COMMUNITY DEVELOPMENT DEPARTMENT REPORT

SUBJECT: Storm Crest
H-2026-0024

Annexation of 11.438 acres of land with R-15 zoning district and a preliminary plat consisting of 71 buildable lots and 14 common lots.

STORMCREST SUBDIVISION
PRELIMINARY PLAT LANDSCAPE PLAN
MERIDIAN, ID

E. Landscape Plan (date: 5/4/2026)

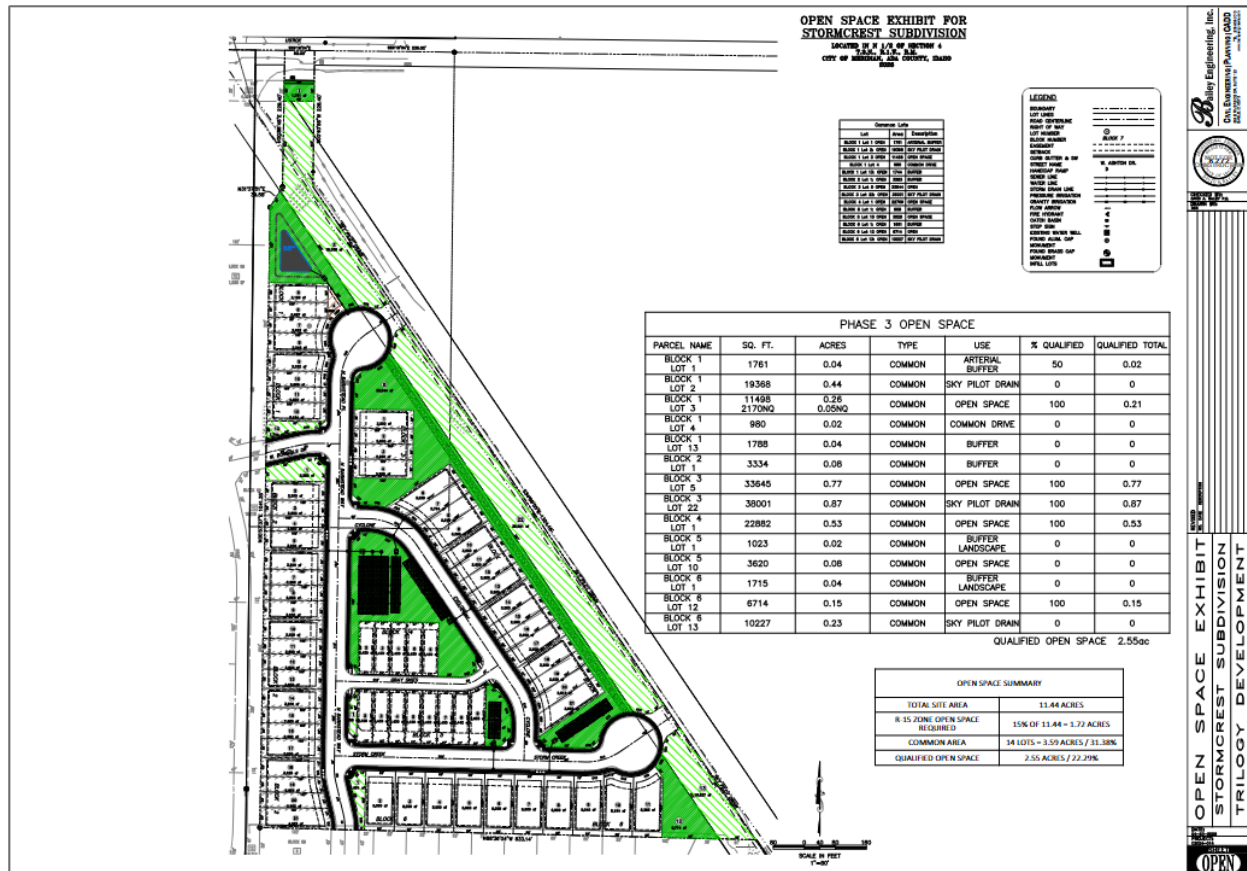
The proposed landscape plan shows the narrow strip of land along Ustick Road with a 35-foot buffer. However, a portion of the landscape buffer is inside of the Sky Pilot Drain easement which may affect vegetation coverage. If the applicant cannot meet the vegetation coverage requirements, alternative compliance shall be submitted with the final plat application.

The applicants landscape plan shows 118 caliper inches may need to be mitigated for. Prior to the Final Plat application being submitted, the applicant shall have the City Arborist verify which trees need to be mitigated for and which do not.

The applicant is proposing a ten (10) foot multi-use pathway along the Sky Pilot Drain. The applicant is proposing landscaping that appears to meet the requirements in UDC 11-3B-12; however, the applicant did not specify the type of landscaping in the planter bed along the west portion of the pathway. The applicant shall revise the landscape plan to more clearly depict the type of landscaping with the final plat record.

3. The landscape plan submitted with the final plat shall include the following revisions:
 - a. Include mitigation calculations on the plan for existing trees that are proposed to be removed in accord with the standards listed in UDC 11-3B-10C.5. The Applicant shall coordinate with the City Arborist (Kyle Yorita kyorita@meridiancity.org) to determine mitigation requirements prior to removal of existing trees from the site.

- b. A portion of the landscape buffer is inside of the Sky Pilot Drain easement which may affect vegetation coverage. If vegetation coverage requirements cannot be met, the applicant shall apply for alternative compliance with the final plat application.

- c. Provide landscaping in the planter bed along the west portion of the pathway in compliance with UDC 11-3B-12.
 - d. Add a eight (8) foot parkway and five (5) foot detached sidewalk along the front of Lots 2-9, Block 5.
